1 FLOOR PLAN

McDONALD'S RESTAURANT
2017 MAJOR REMODEL PROGRAM
State Site Code: 022-0316 Nat'l Number: 18751
7997 SOUTHTOWN CIR. BLOOMINGTON, MN

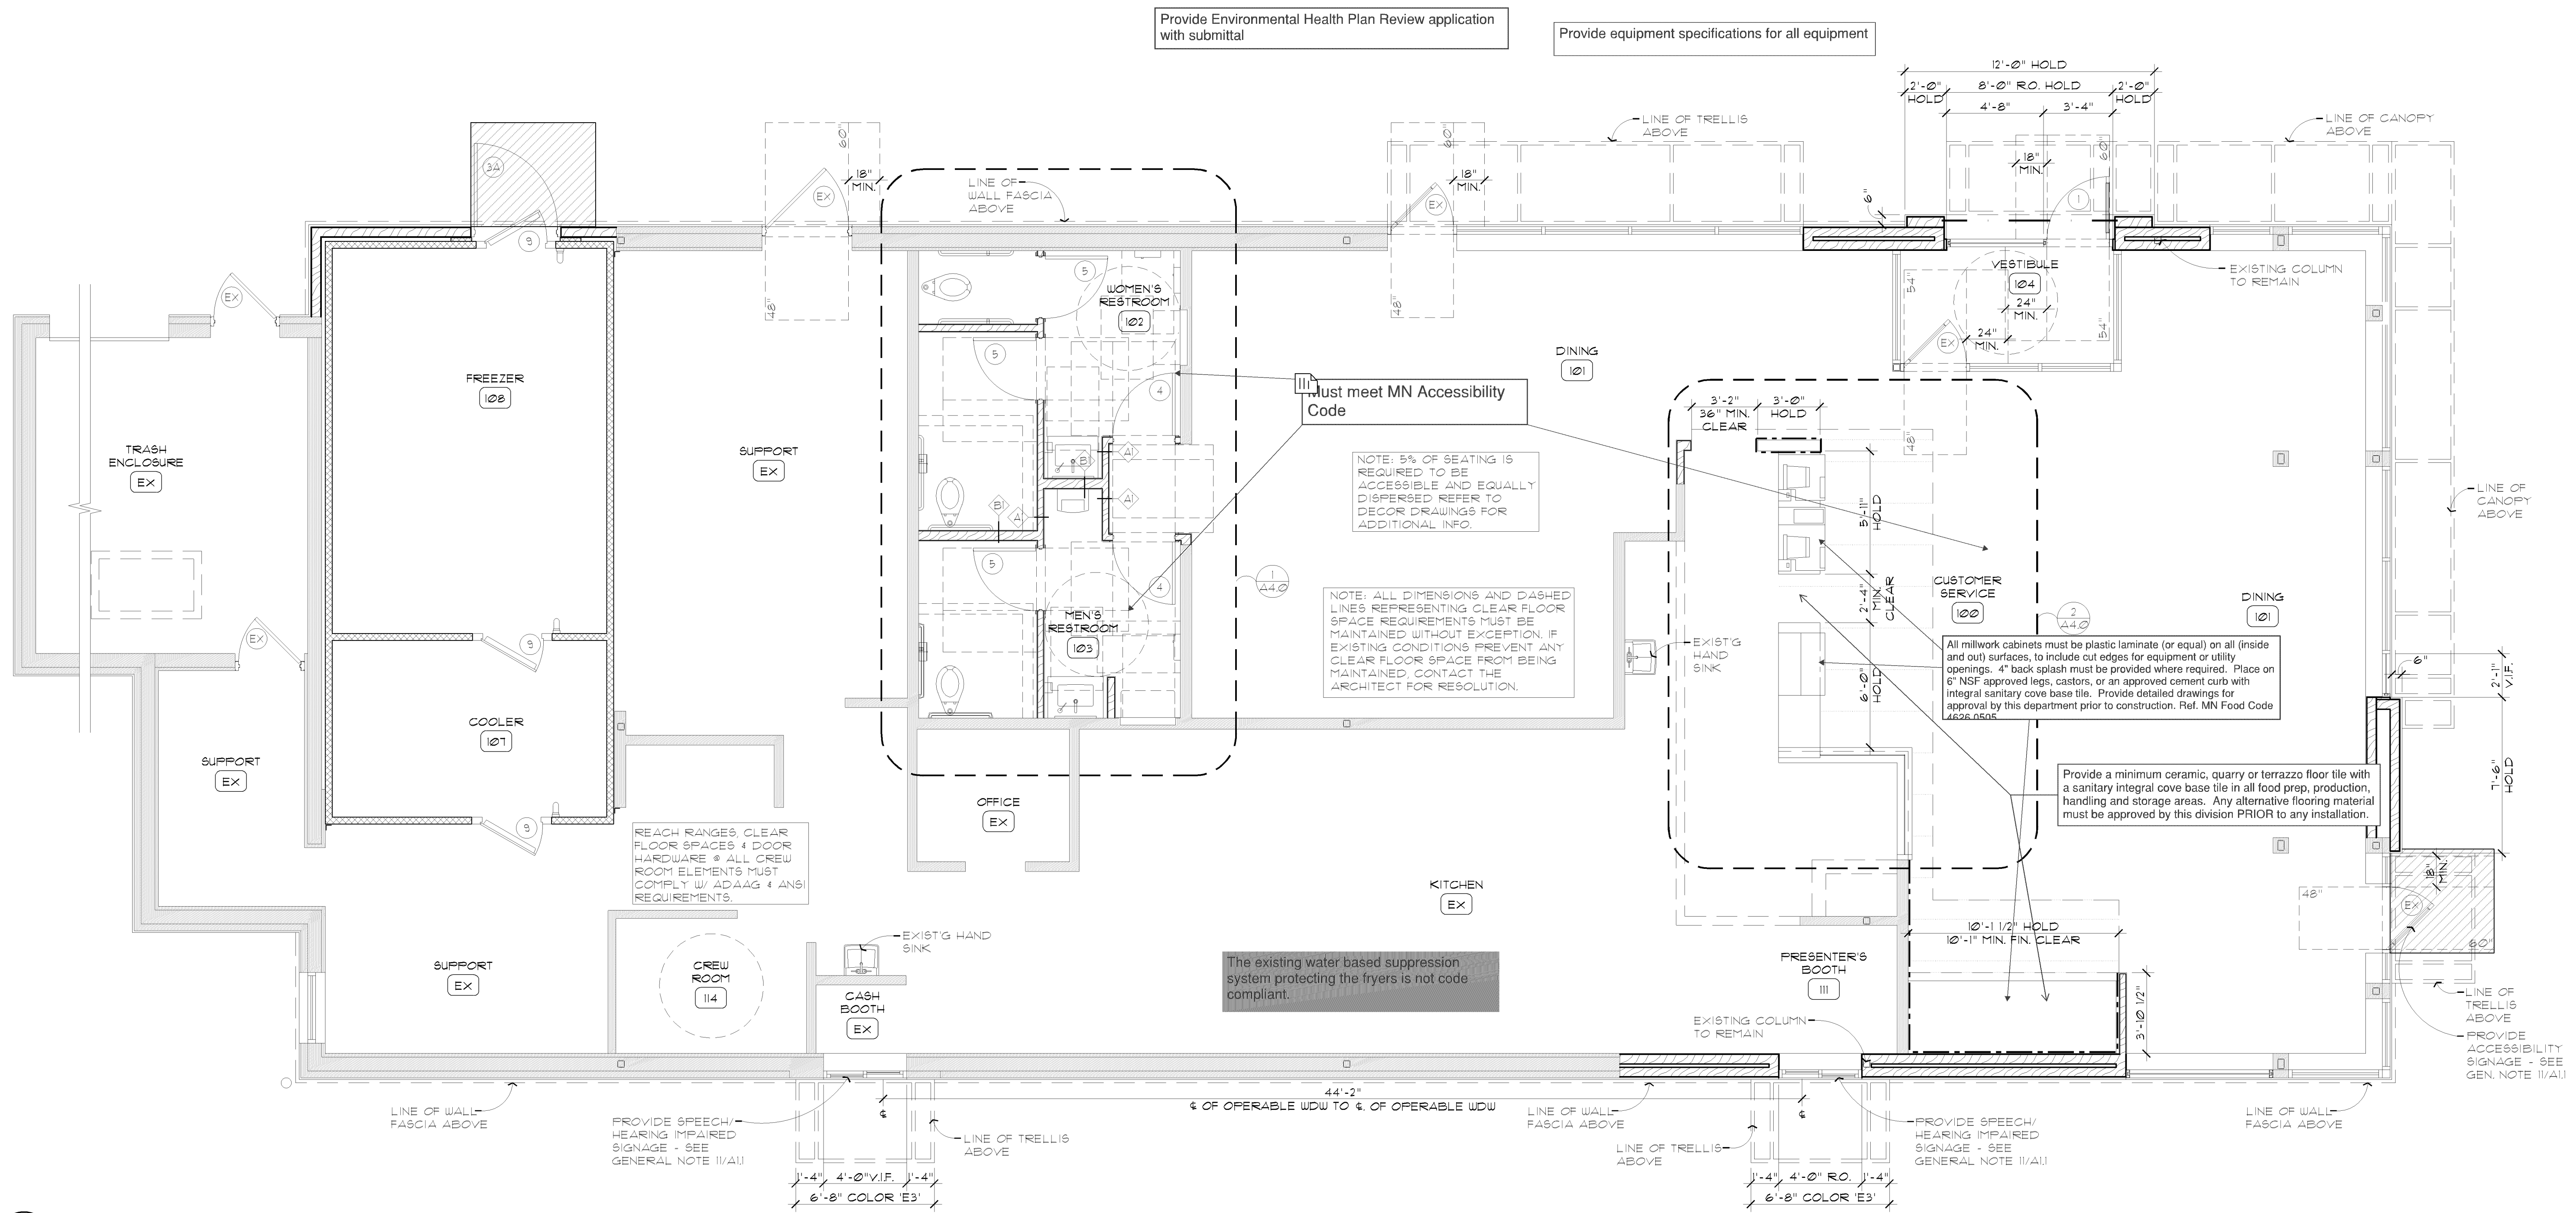
Provide Environmental Health Plan Review application with submittal

Provide equipment specifications for all equipment

Must meet MN Accessibility Code

The existing water based suppression system protecting the fryers is not code compliant.

Must meet current MN State Building Code

20% of budget must be applied to accessibility updates(remodels)?????
